**APPENDIX D**

**WCAP-1530, Revision 1 dated April 2001**

**"Surry Units 1 and 2 WOG Reactor Vessel 60-Year Evaluation Minigroup Heatup  
and Cooldown Limit Curves for Normal Operation"**

**Surry Units 1 and 2  
WOG Reactor Vessel 60-Year Evaluation Minigroup  
Heatup and Cooldown Limit Curves  
For Normal Operation**

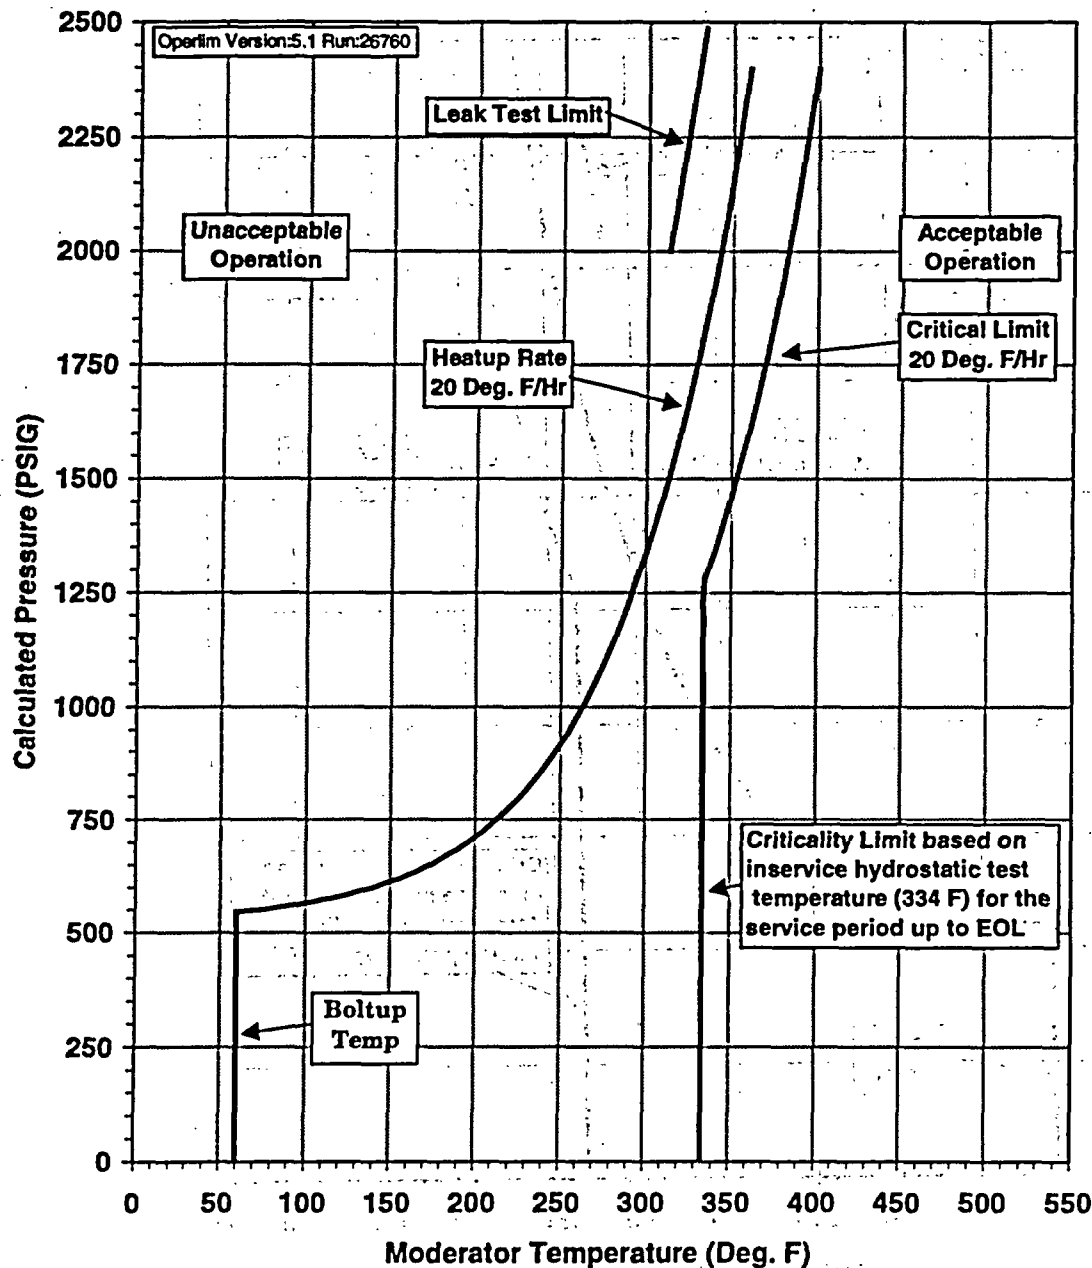
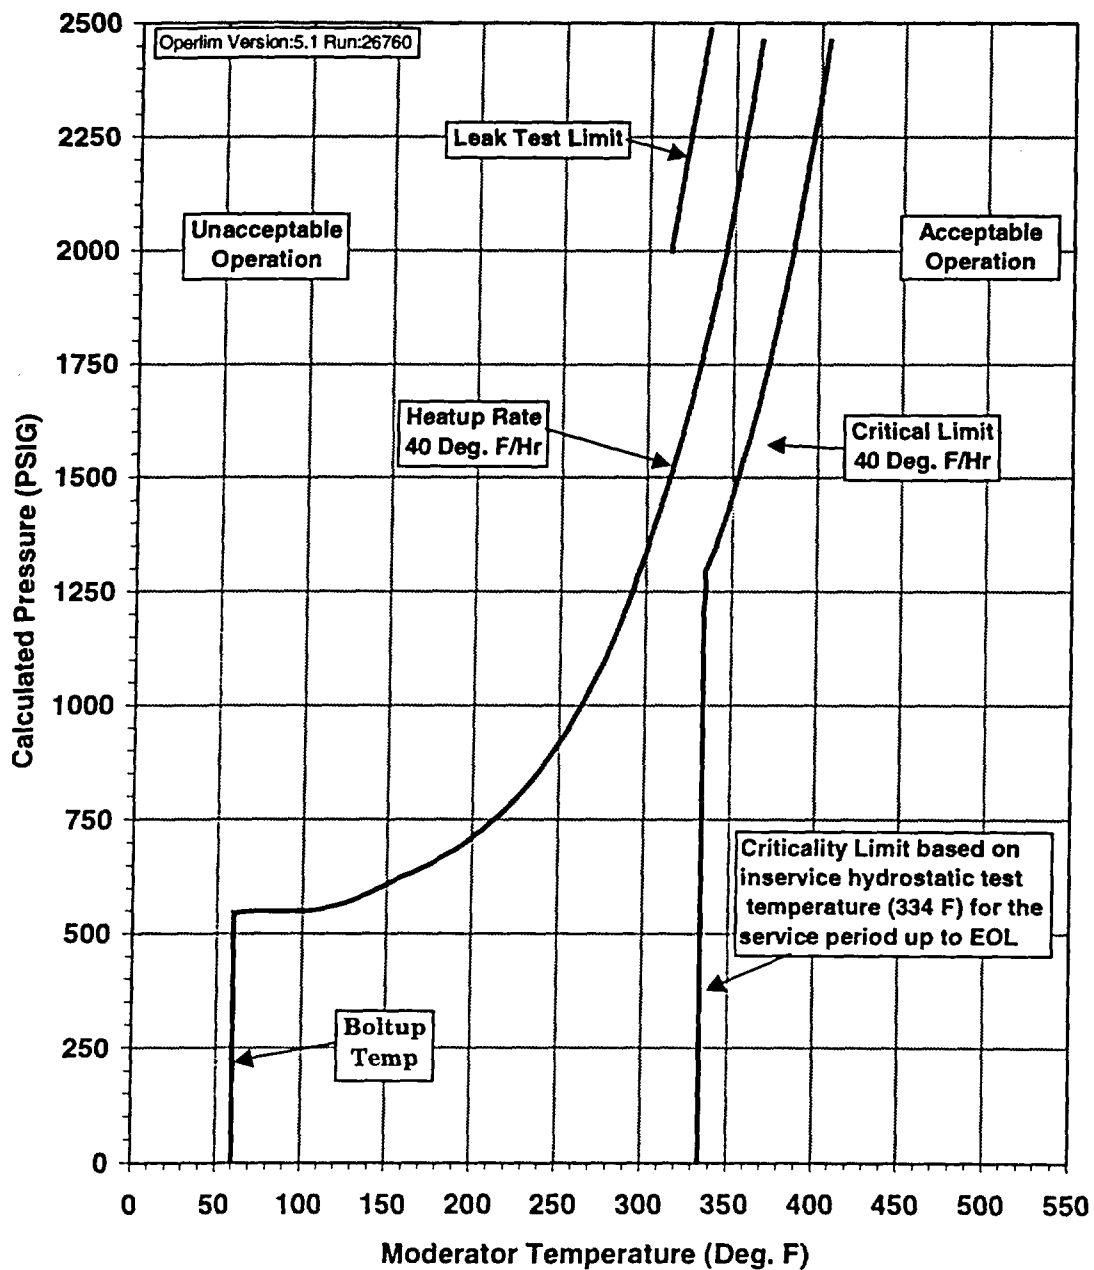
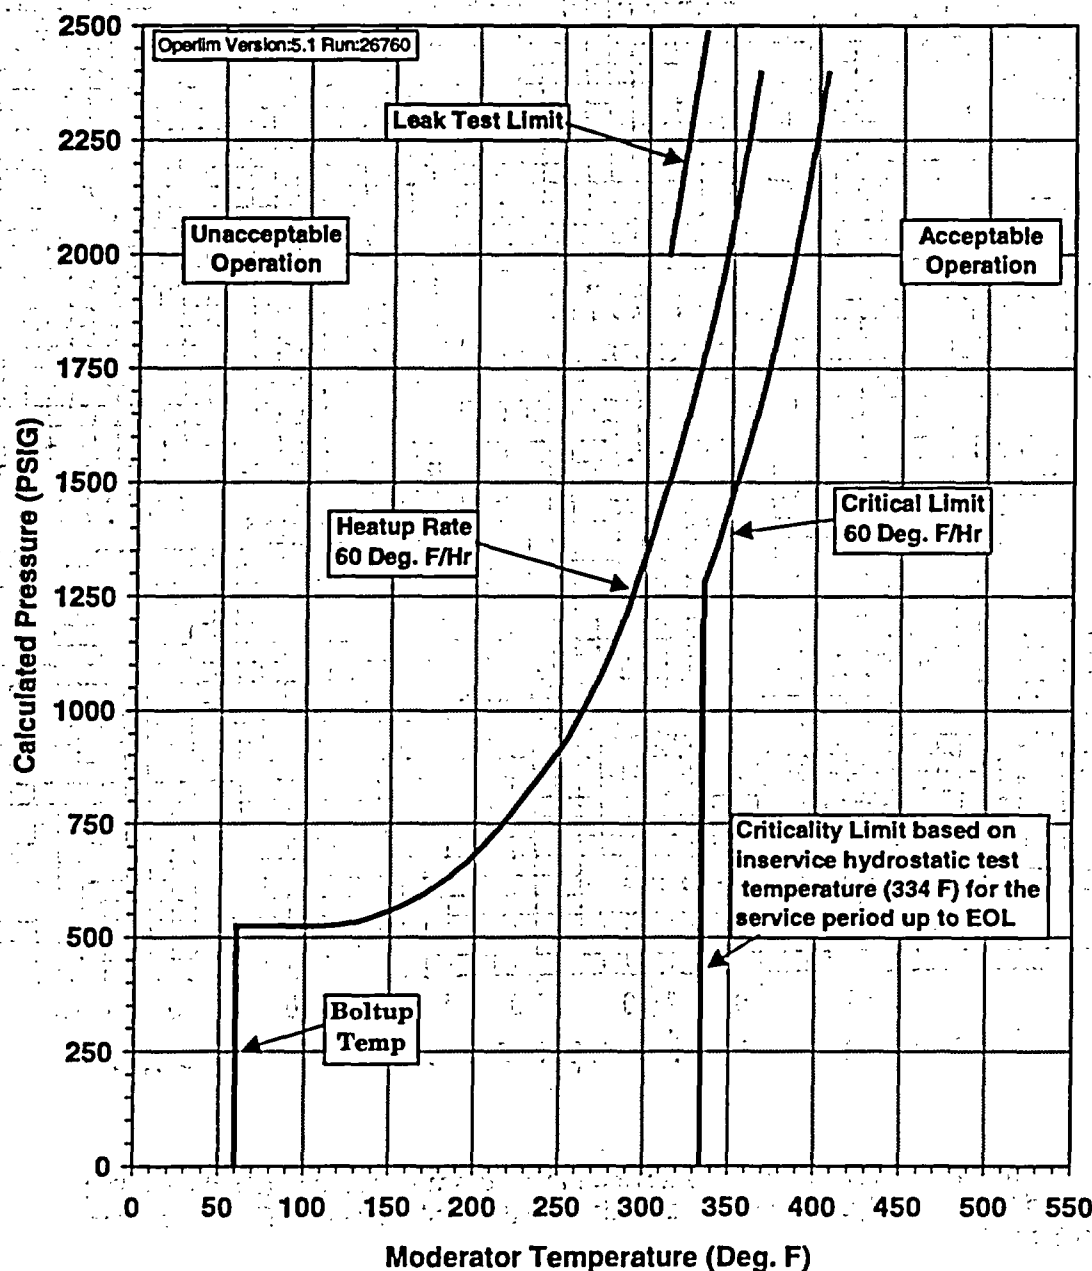
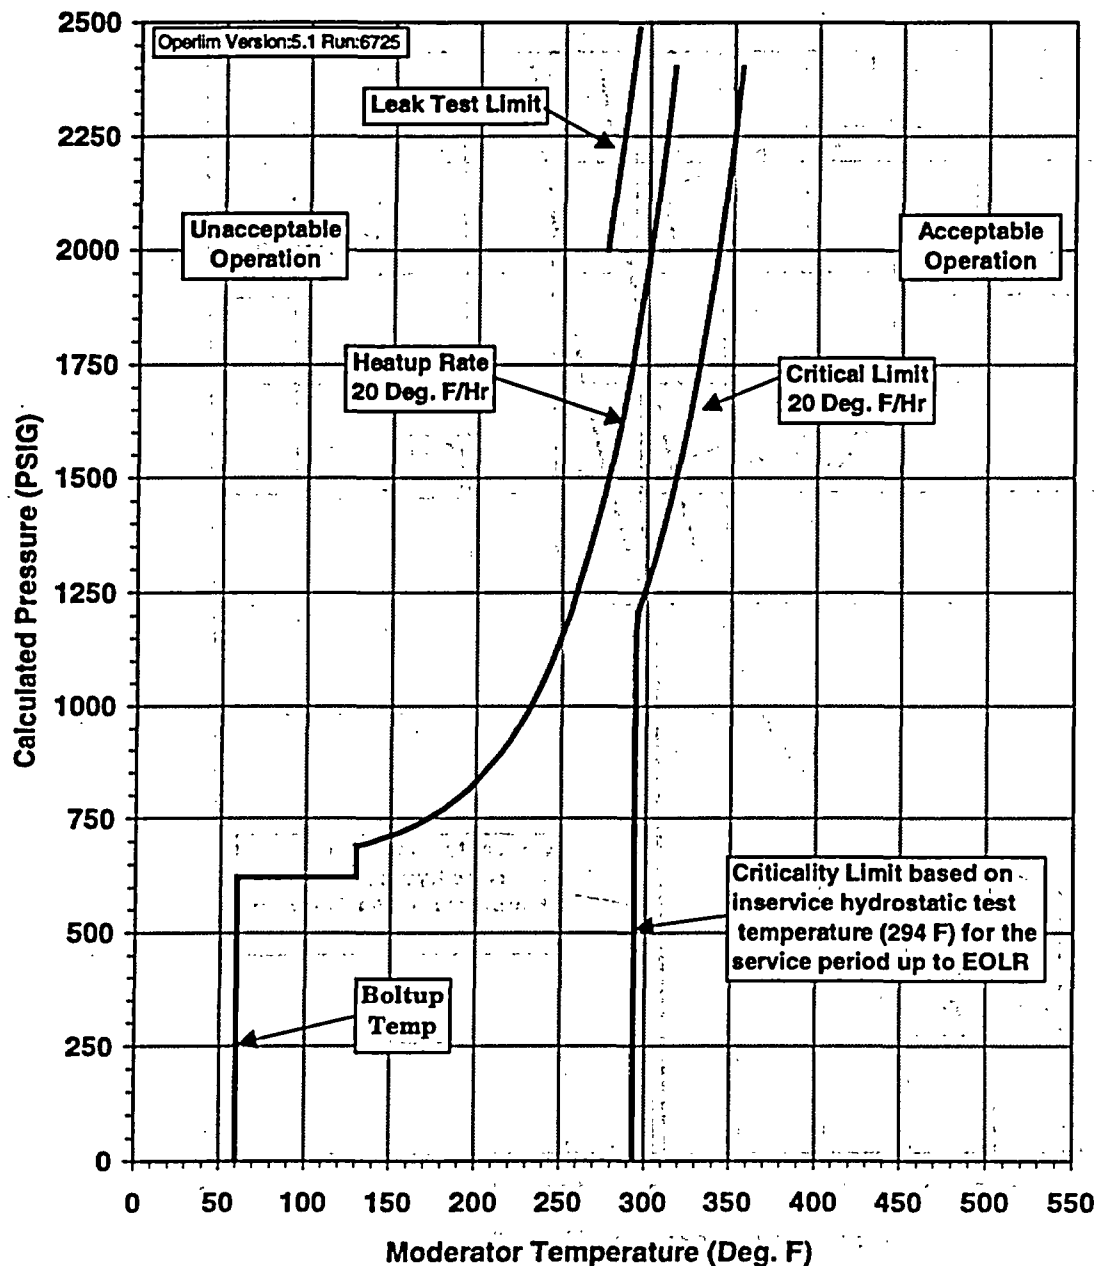
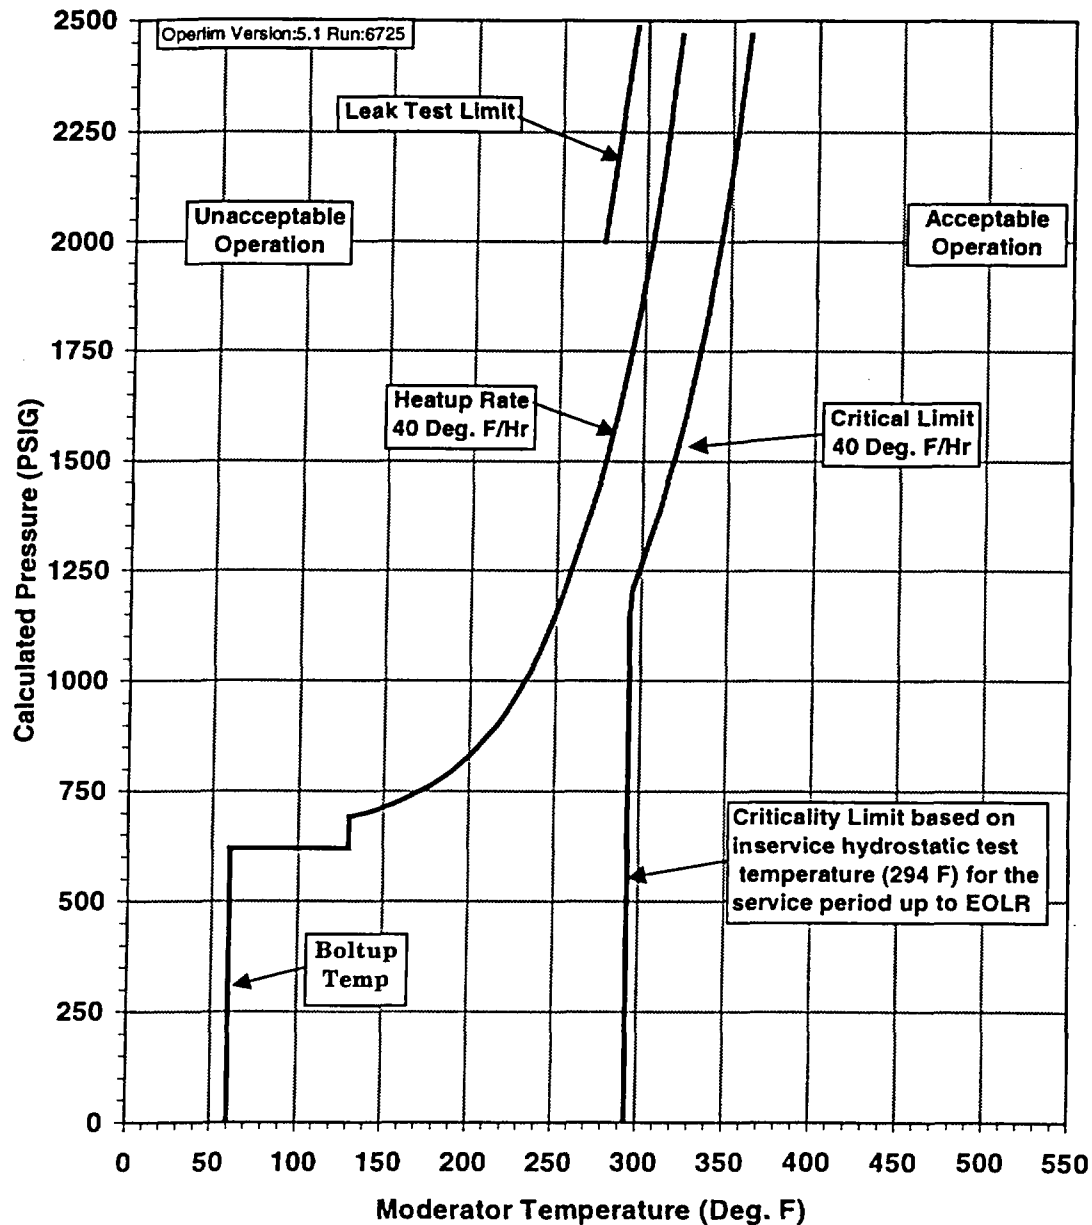
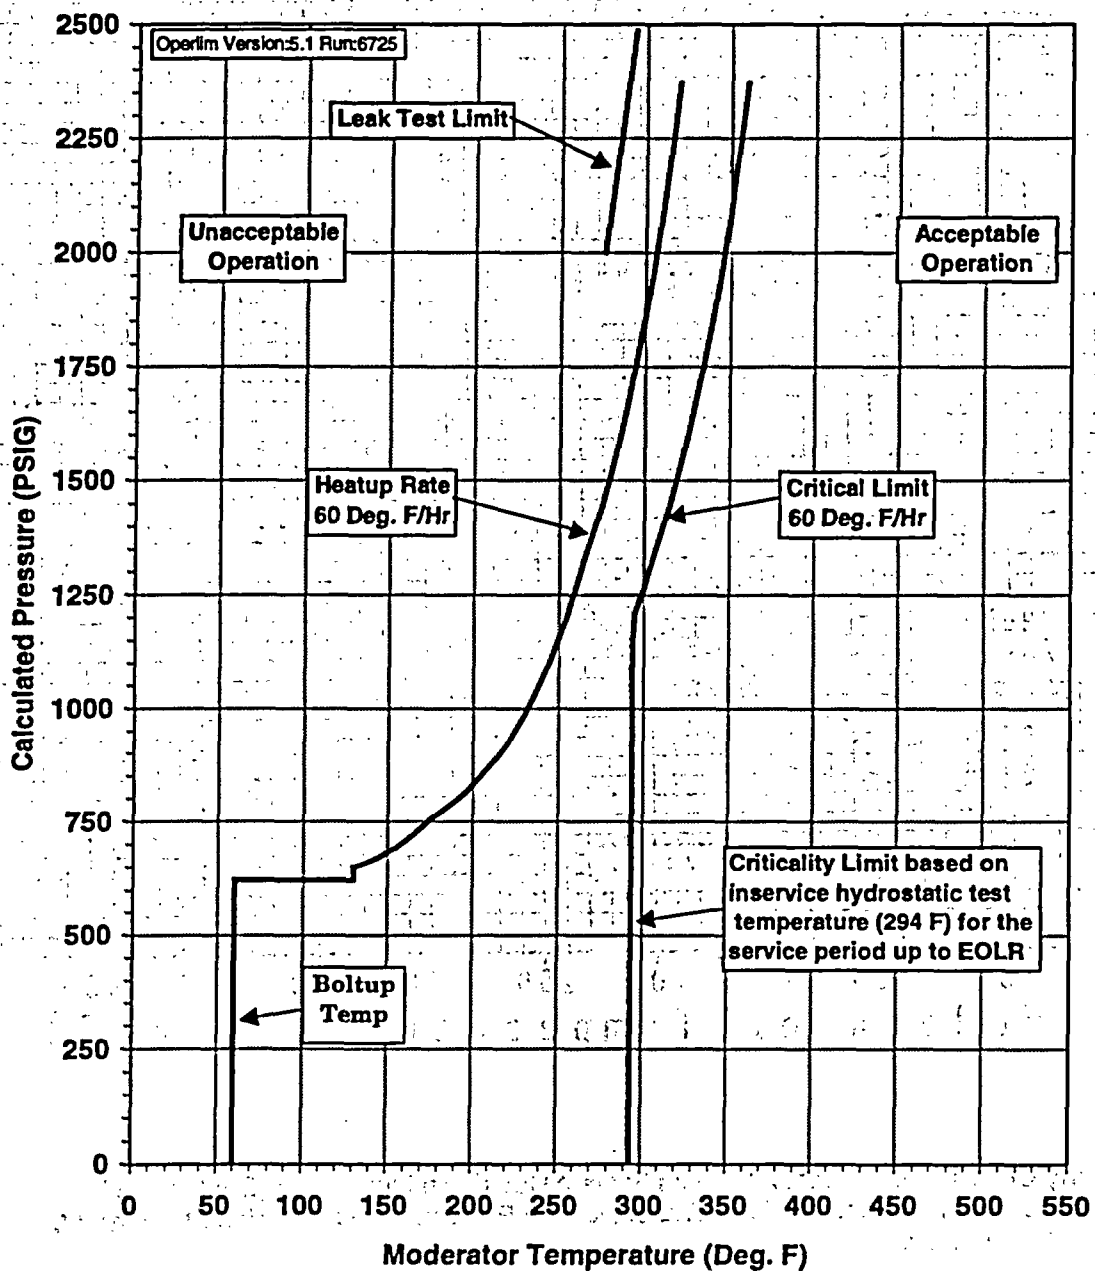
An error was detected in the "OPERLIM" Computer Program that Westinghouse uses to generate pressure-temperature (PT) limit curves. This error potentially effects the heatup curves when the 1996 Appendix G Methodology is used in generating the PT curves. It has been determined that WCAP-15130 Rev. 0 was impacted by this error. Thus, this revision provides corrected curves from WCAP-15130 Rev. 0.

Note that only the heatup curves and associated data point tables have changed. The cooldown curves and data points remain valid and were not changed.
